PIC - M047090
Plan submittal
Figure 1 &
4b

From: "Linda Matthews" <lmatthews@jbrenv.com>
To: <bethericksen@utah.gov>, <pamsandberg@utah.gov>
CC: "Barclay Cuthbert" <barclay.cuthbert@earthenergyresources.com>
Date: 05/15/2008 2:29 PM
Subject: Earth Energy PR Spring NOI (M/047/0090)
Attachments: Fig4b Transverse Mine Section W2-E2.pdf; Fig1 Location Map Layout1 (1).pdf

Figure 4b
Earth Energy Resources Inc. - PR Spring Oil Sand Mine
Transverse Mine Section W2-E2 Rev.2

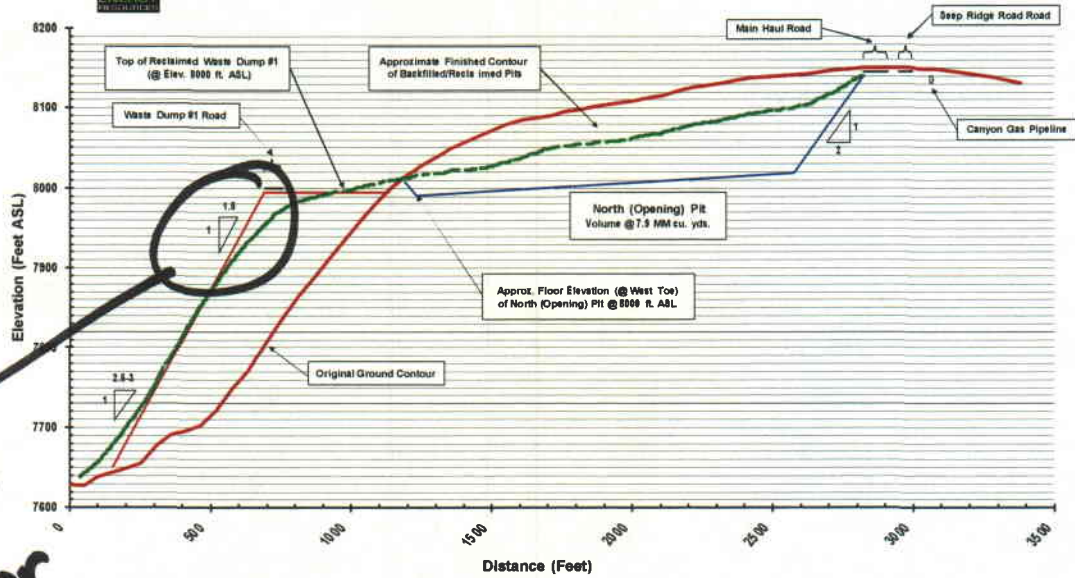
Based upon our phone conversation this morning, I am attaching Figure 1 for the Earth Energy PR Spring NOI - which was unfortunately omitted in the May 9, 2008 submittal; and Figure 4b - which was revised to show the accurate horizontal to vertical alignment of the reclaimed waste dump slope at 1.5 H:1V. Please accept these Figures for the May 9, 2008 response to the Initial Review of NOI to Commence Large Mining Operations, Earth Energy Resources, PR Spring Mine (M/047/0090).

changed
was
in error
in May
'08
submittal
